# GLASTIR ADVANCED POST VISIT ASSESSMENT

**DAT 105841**

**Site Name: Fronlas Isaf**

## **Introduction and historic background**

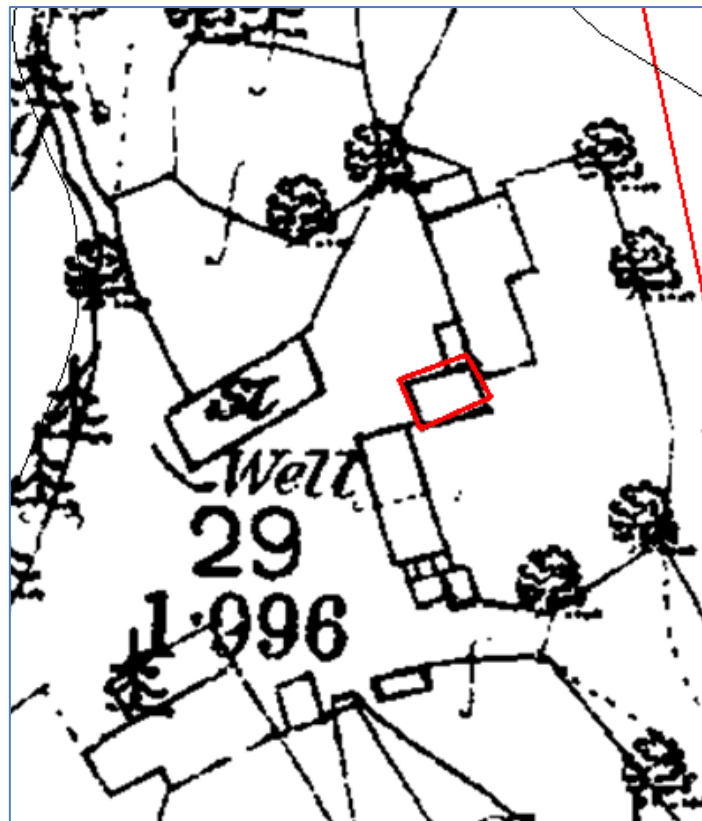
The building subject to this advice lies in the centre of the old range. From the photographs provided the building can be seen as a single storey stone built

building under a slate roof. A small window in the gable end suggests a loft space. Two openings on the north side have squared stone reveals. It is traditional farm building with a good level of survival which is known to be part of the historic core of the farm. As such DAT welcome the proposal to repair the building under the Traditional Building Repair Option.

The most significant management issue is the NW corner where substantial parts of the masonry has collapsed. Also along the wall head on the north side there loose slate and vegetation growing.

- repair to the NW corner using the original fallen stone where possible.
- Invasive vegetation should be removed from the wall heads.
- Loose slates on the wall heads to be re-set.
